SUBDIVISION REVIEW SHEET

CASE NO.: C8J-2021-0080.0A

SUBDIVISION NAME: Whisper Valley Multifamily Parcel 65 Preliminary Plan

CITY OF AUSTIN – TRAVIS COUNTY – SINGLE SUBDIVISION OFFICE SUBDIVISION APPLICATION – MASTER COMMENT REPORT

GRADING PLAN
WHISPER VALLEY
MULTIFAMILY PARCEL 65
AUSTIN, TEXAS

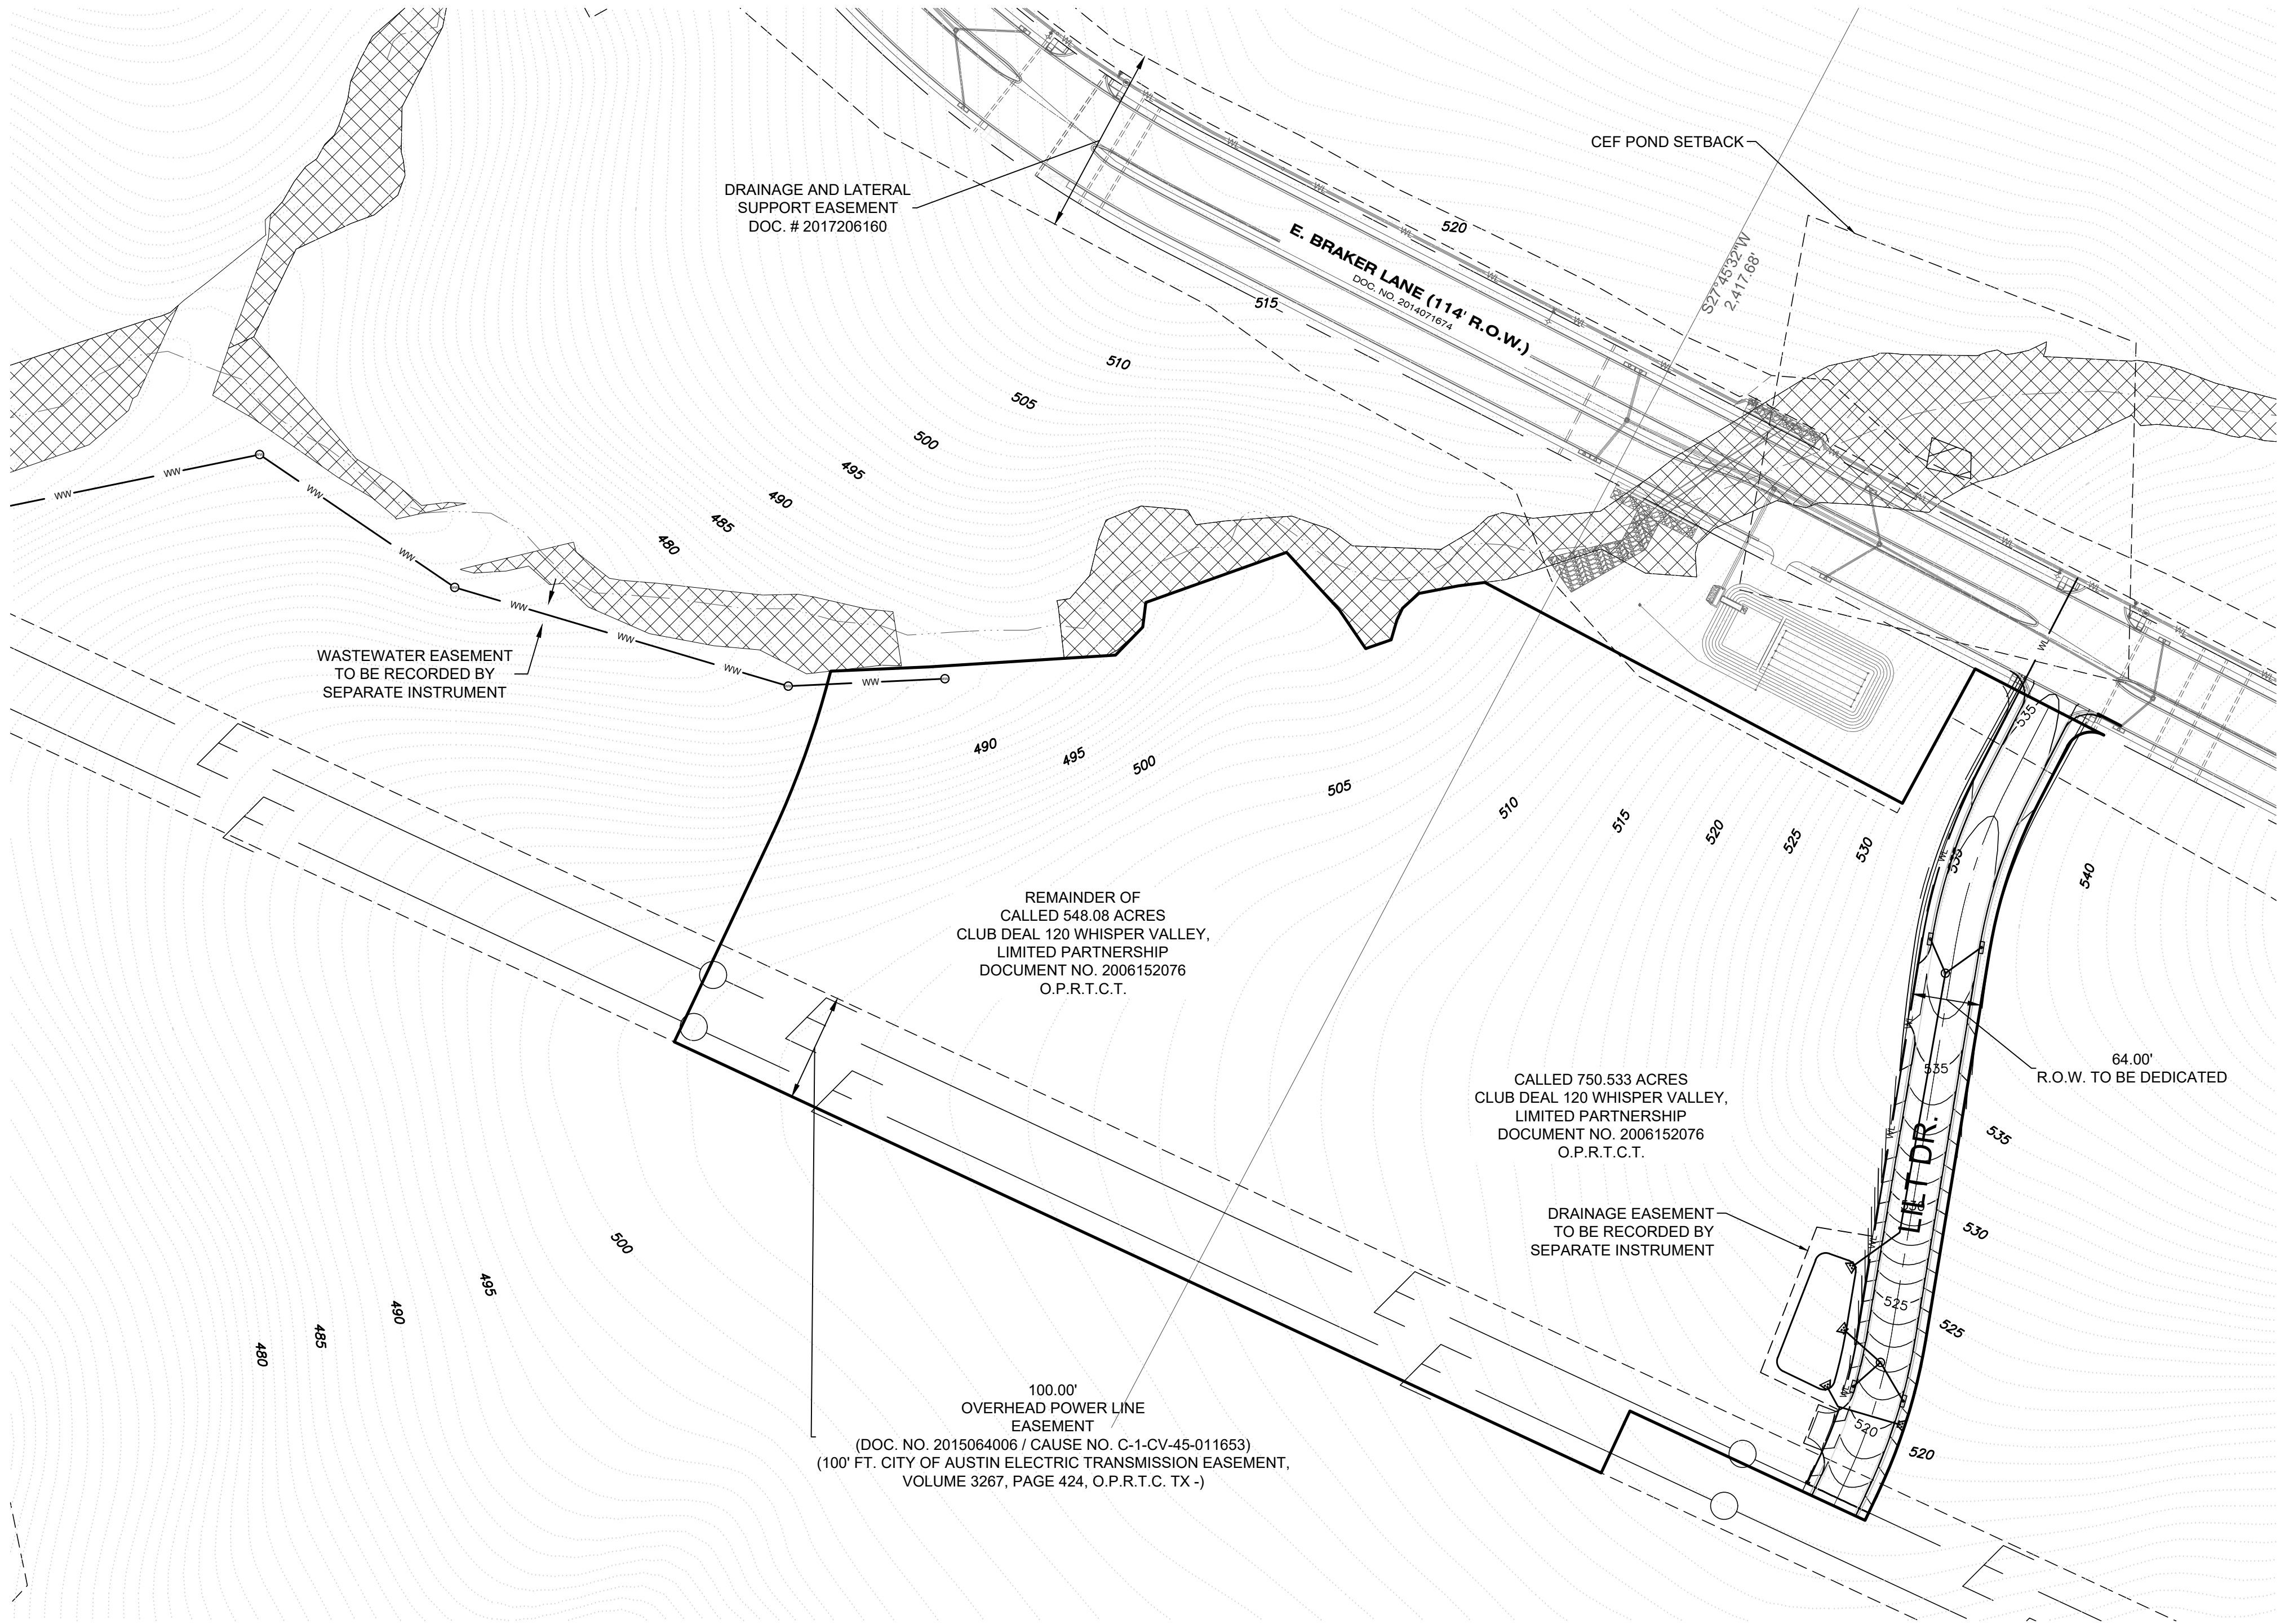
EV 10 It may be necessary to resubmit this project through the Project Assessment. The proposed grading plan must demonstrate compliance with applicable regulations and rules. [LDC 30-5, Article 7; ECM 1.8.0]

Provide a grading exhibit with clear, differentiating hatches or colors for the following categories:

- Cut -4.00 to -8.00 feet
- Cut greater than -8.00 feet
- Fill 4.00 to 8.00 feet
- Fill greater than 8.00 feet
